5. CASE 22. 092, 171 CONGDON STREET, Ephraim Martin House, 1856 (COLLEGE HILL)

Project: Three Family Residence  
Address: 171 Congdon Street, Providence, RI 02906  
Date: 18 August 2022 - Revised  
Re: Application Information

## **NARRATIVE – Scope of Work**

1 WEST ELEVATION - CONGDON STREET  
A2.1 1/4" = 1'-0"

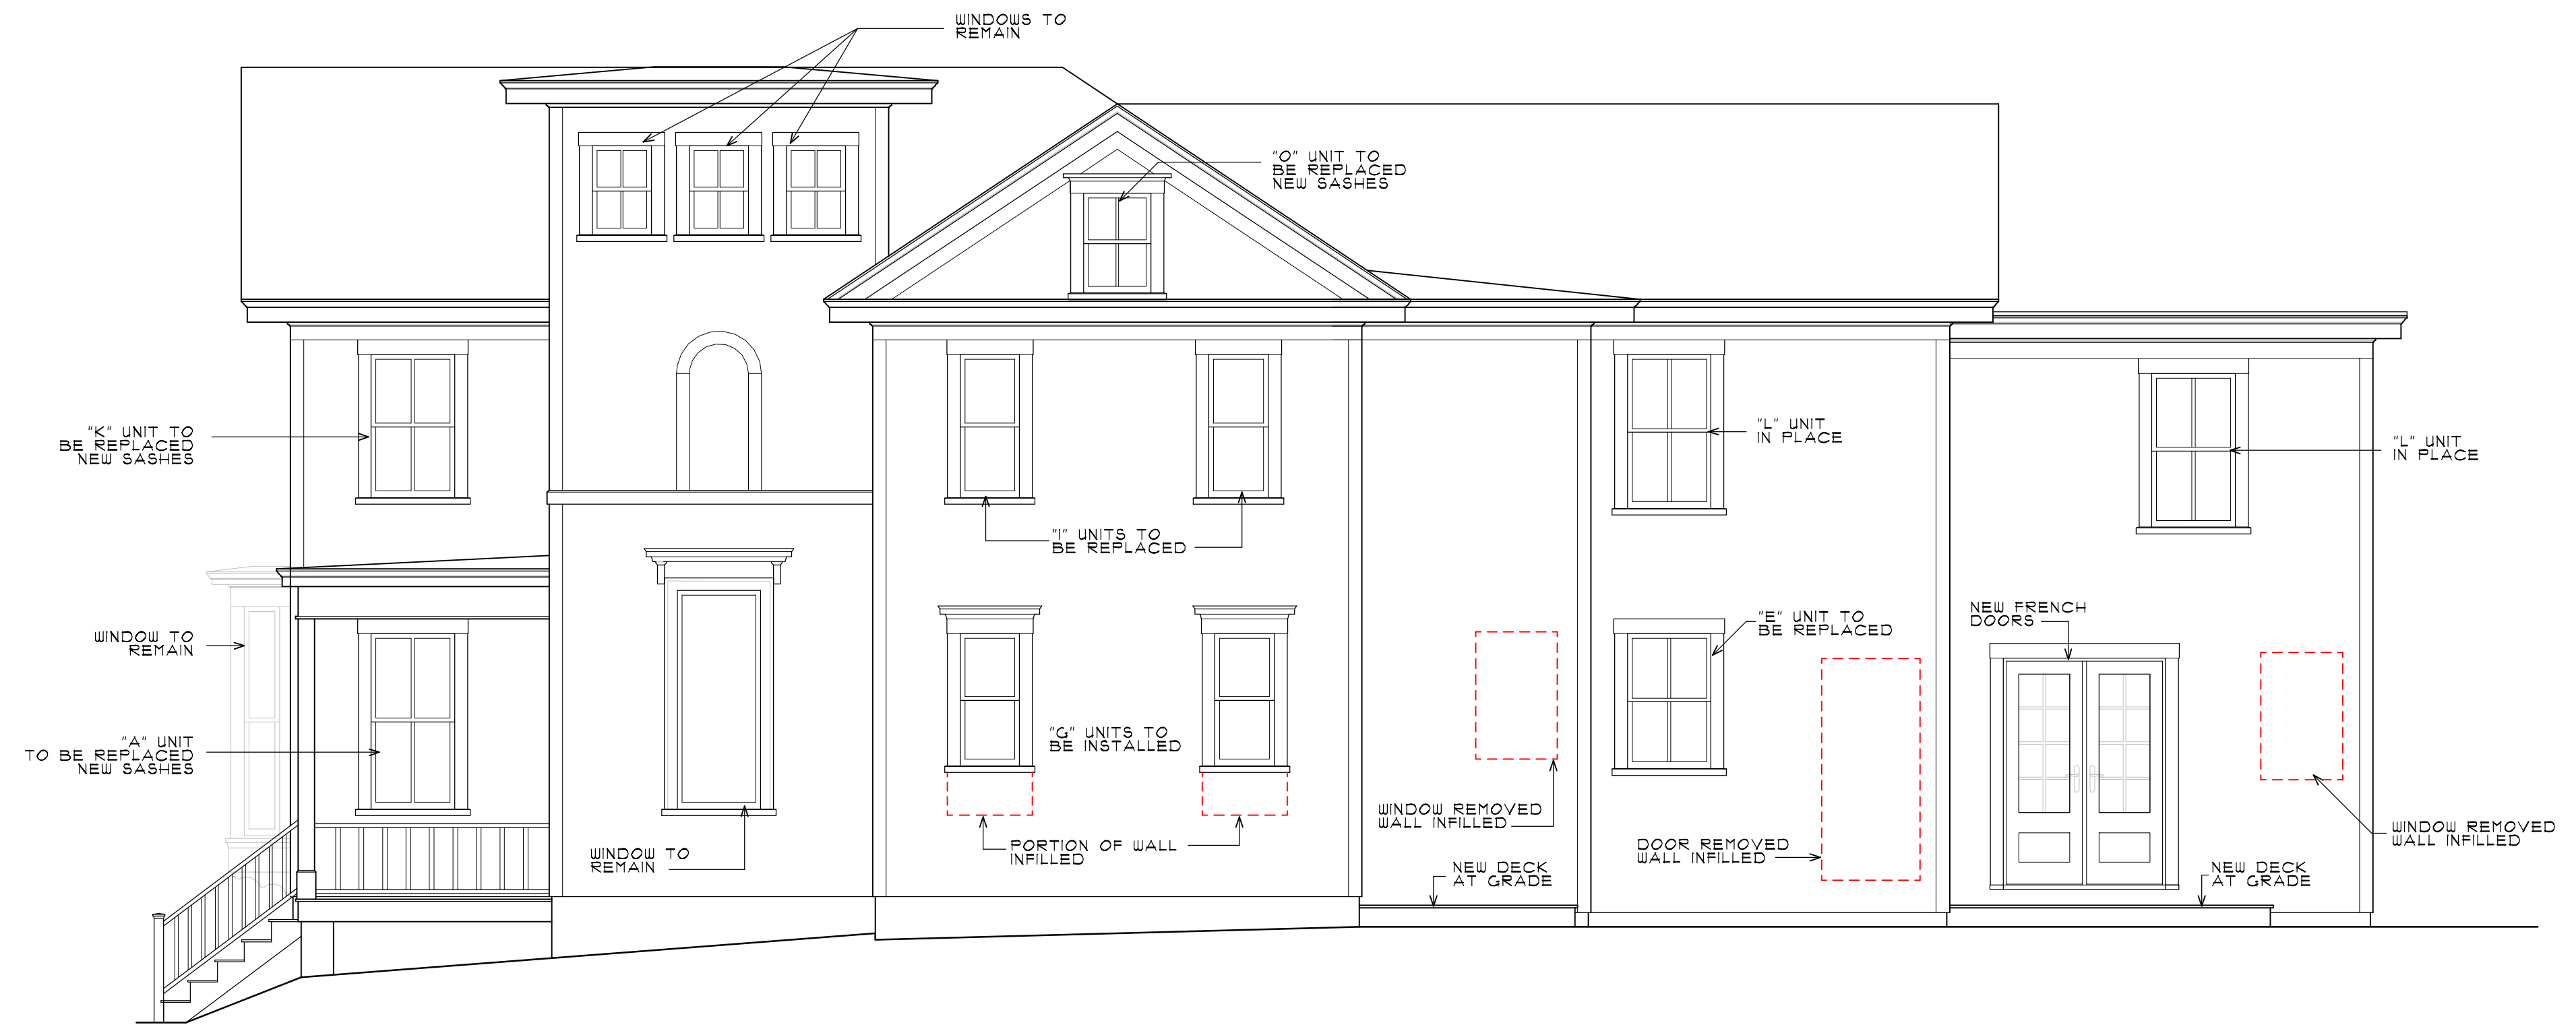
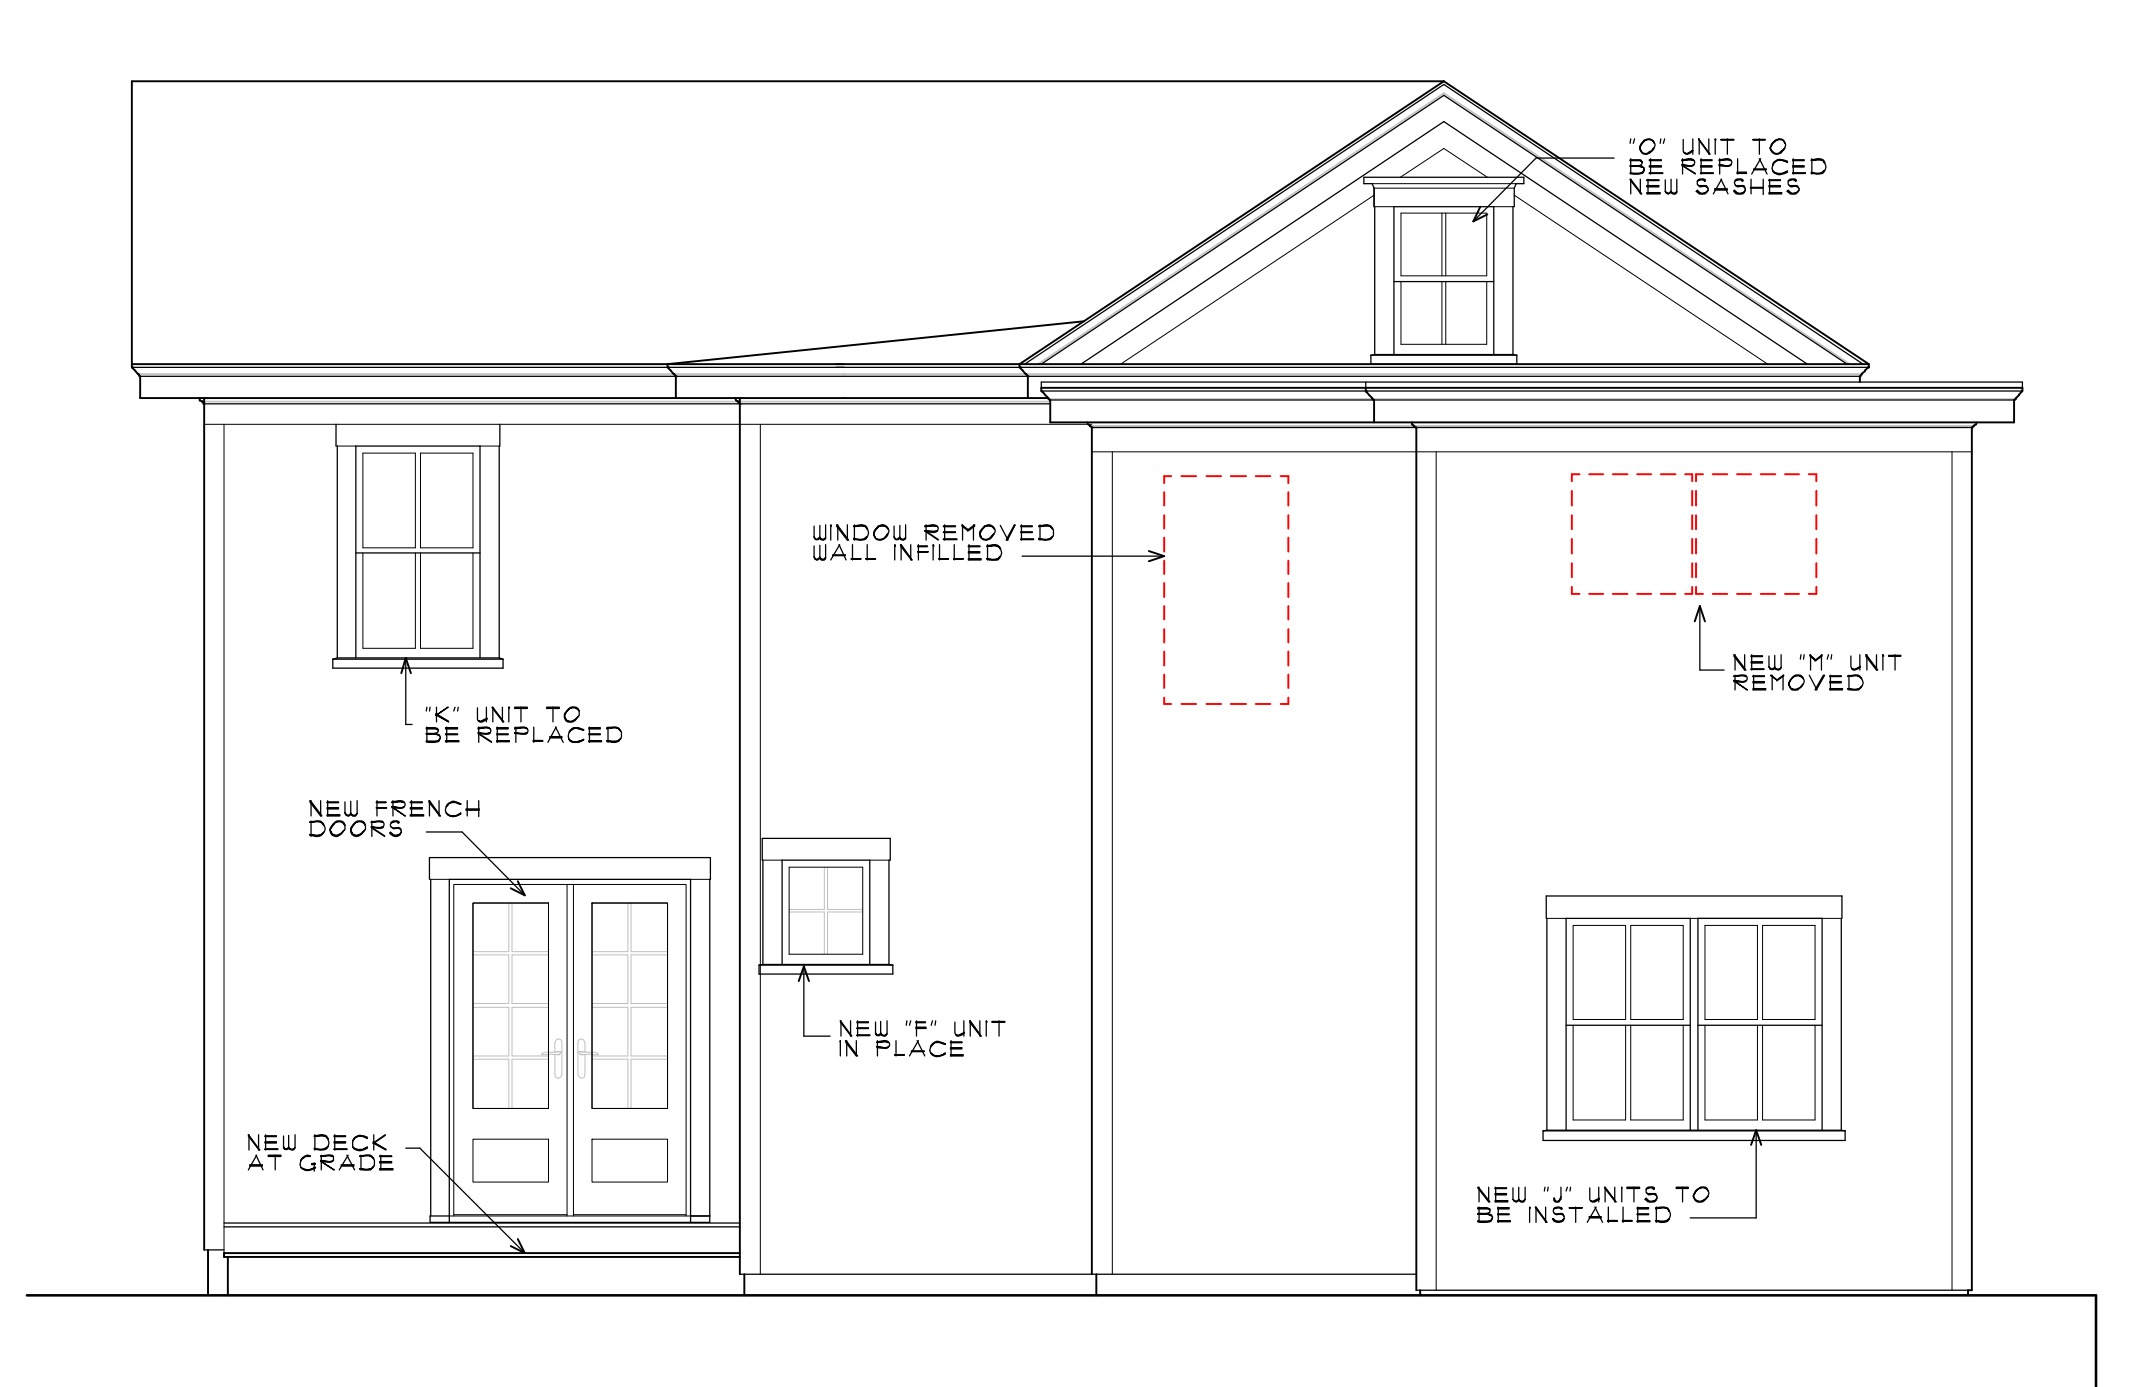
Pair of awning windows on east elevation shall be removed and wall infilled

North Elevation – New 6 panel fiberglass door. w/ two lights, has been installed to provide entry access to rear unit. Painted wood casings to match house casings.

North Elevation – New entry porch 4' x 5' shall be 1x6 Trex on P.T. framing. Rails to be painted wood as shown.
